Addressed by:

From the Murphy Family at 1251 Claremont

Original Design (17'3" from 2nd Floor Pitch to Property Line)

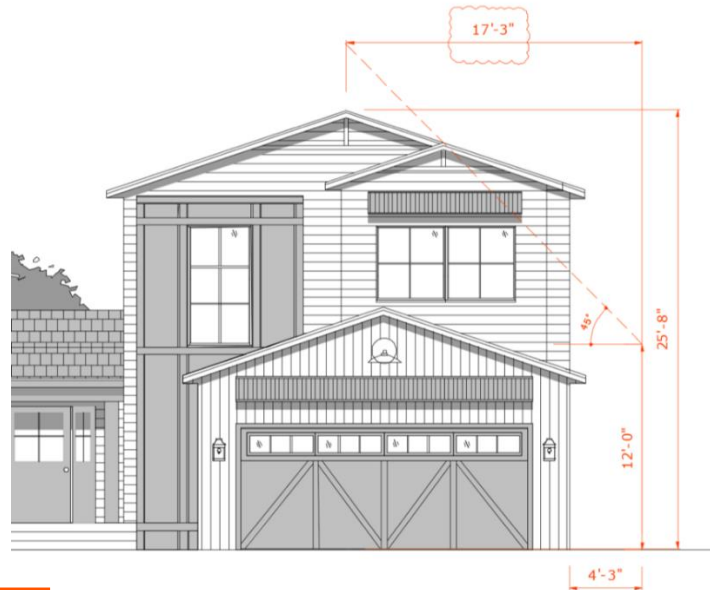
The daylight plane implementation only moves the second-floor roof pitch over by 25 inches, which is why the shading mitigation is almost non-existent

The design complies with the daylight plane. Also, the 2nd floor shifted back 4'1" in the new design.

Current Design (19'4" from 2nd Floor Pitch to Property Line)

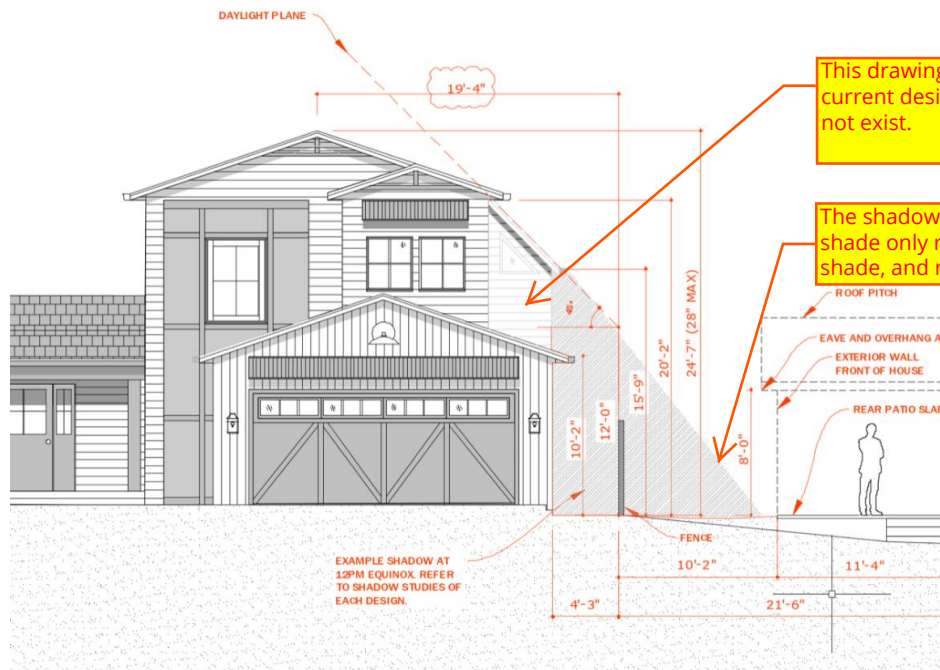
Why did the daylight plane implementation not minimize the shading? The answer is that (1) the Lees property is already almost right on top of ours (for those who visited our property you were able to gain that perspective), (2) The height of the pitch is 24'7", that and the close proximity to our property is the **major cause of the shading and** (3) the daylight plane implementation only moved the pitch away from the property line by 25 inches (**see three pages down for comparison graphic**) and so that pitch is still casting a major shadow

This drawing is **not** the current design. This does not exist.

The shadow is at an angle. The floor in shade only represents the ground in shade, and not all the the space above it.

3.13 PRIVACY AND SOLAR ACCESS

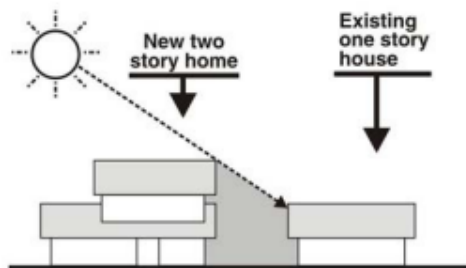
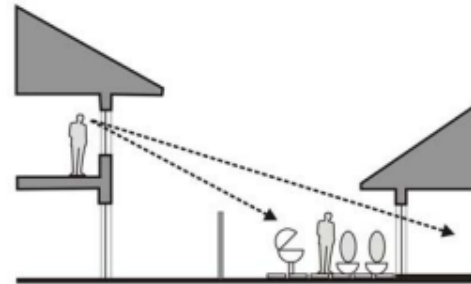
We at 1251 Claremont have been seeking an equitable solution from the very beginning and we haven't received it. This design only benefits 1261 because the shading has not been sufficiently minimized – **See four pages down** for the language of design guideline 3.13.1, which says “minimize shadow impacts on adjacent properties” → **Minimizing the impact by 3% does not comply.**

We have complied to this with the daylighting

We have complied to this and have all windows facing 1251 will be transom windows.

1251 CLAREMONT REAR YARD SHADOWS & EXISTING FOLIAGE

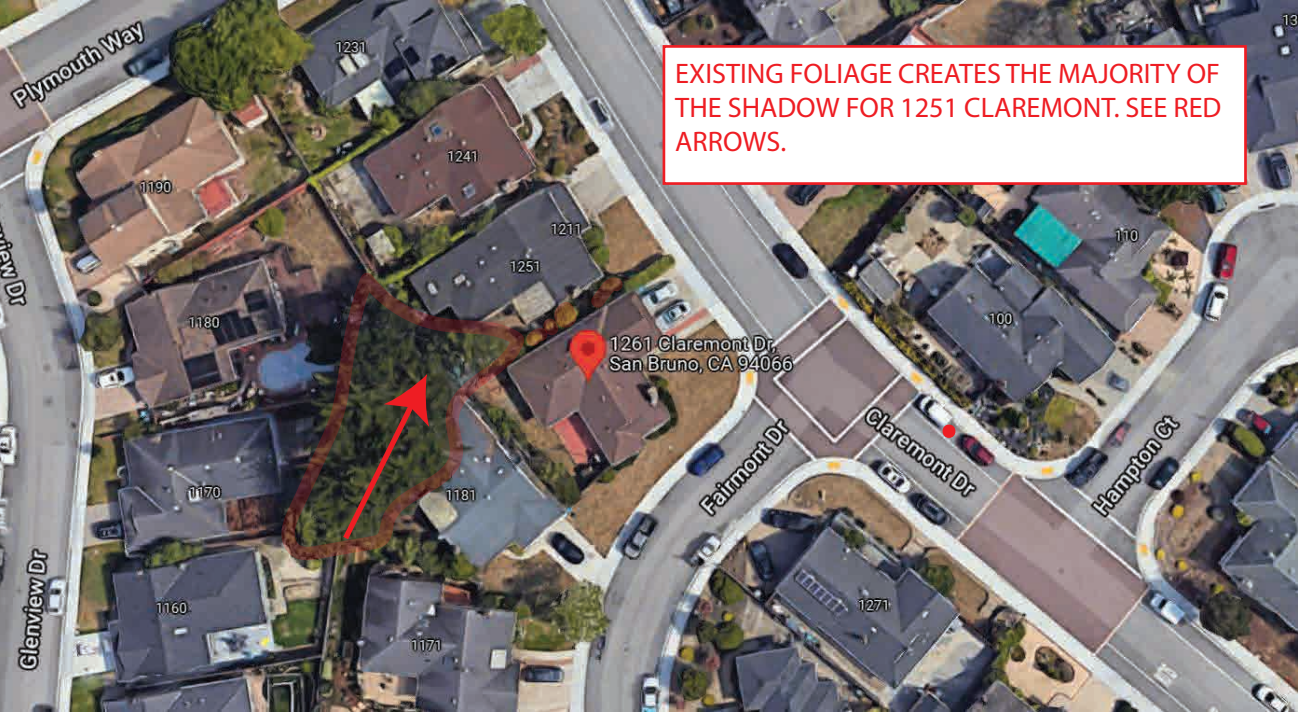
In addition to the backyard area getting sun, the house structure and windows also get sun early in the morning – this is important and would be completely mitigated by the second story on the north wing.

Please refer to the shadow studies. This is misleading, and does not show how the shadows move and duration. Nor does it show Shadow angle or lengths.

The pinkbox is from the second floor shadow, and is inside the existing 1st floor shadow.
